SERVICE PROCEDURE

19513

SUBJECT: SAFETY RECALL
Emergency Roof Hatch on certain IC Bus® CE Series and RE Series school bus models built 30 August 2018 thru 11 July 2019 with feature codes 48PZP, 48PZR, 48RZY, 48SXV, or 48SZG (Prolo hatch).

Figure 1. Interior Handle

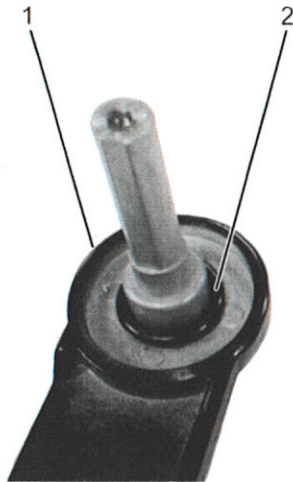
5. Working from vehicle interior, locate and access emergency roof hatch (Figure 1, Item 1).
6. Rotate interior handle to released position (Figure 1, Item 2).
7. Using 1/8-inch Allen wrench, remove screw (Figure 1, Item 3) from interior handle (Figure 1, Item 2). Discard screw.
8. Remove interior handle. Save for reuse.
9. Open hatch 5 to 6 inches.
10. Lift exterior handle out of bushing.

Figure 2. Exterior Handle

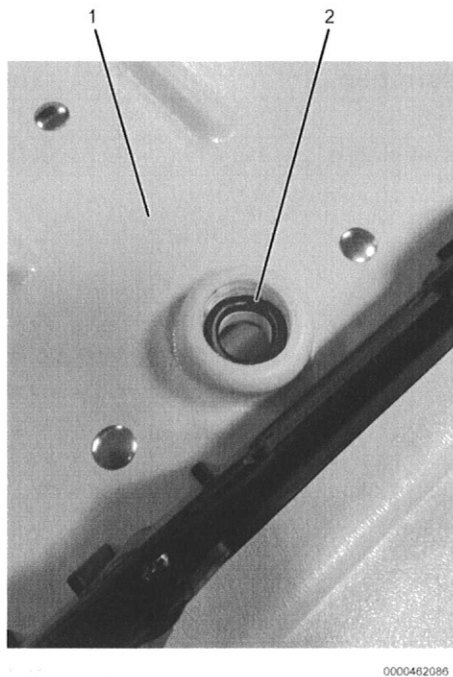
11. Inspect exterior handle (Figure 2, Item 1) for large O-ring (Figure 2, Item 2):
 - a. If large O-ring present, discard exterior handle and O-ring.
 - b. If large O-ring is not present, check to see if present in lid bushing. If present, remove O-ring from lid bushing. Discard exterior handle and O-ring.
12. Install new large O-ring (Figure 2, Item 2) onto new exterior handle.
13. Install exterior handle into lid bushing with exterior handle oriented to released position.
